**AG-MI-2015-02-C-EN – Change of Measurement Method
from Cylinder Head Temperature to
Coolant Temperature**

Category C

29.04.2015

Design change of the Rotax 912 ULS and Rotax 914 UL cylinder heads (introduced 01.03.2013) regarding the measurement procedure for cylinder head temperature (CHT) respectively coolant temperature (CT)

Fig. 1 – New generation cylinder head (measurement of CT)

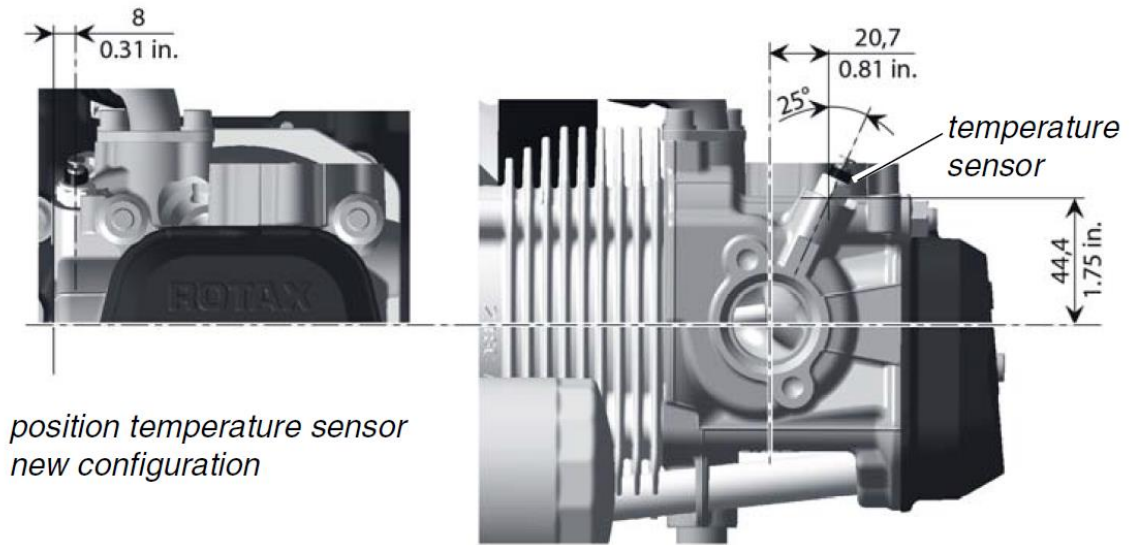
For engines equipped with new cylinder heads (see figures 1 and 2) change instrument marking of the cylinder head temperature indicator (CHT) to coolant temperature (CT). A replacement instrument will be purchasable later.

- 1 If necessary: Remove engine cowlings according to MMM 52-00-00 4-1
- 2 Check configuration state regarding cylinder head design (see figures 1 and 2)
If new cylinder head design is detected:
- 3 Clean CHT instrument glass with glass cleaner
- 4 Change cockpit instrument for cylinder head temperature (CHT) to coolant temperature (CT) using the modification set (see Parts List). Therefore in accordance with Fig. 3:
 - Stick the red radial on the instrument glass at 120°C
 - Stick coolant temperature pictogram on the instrument glass above "CHT"
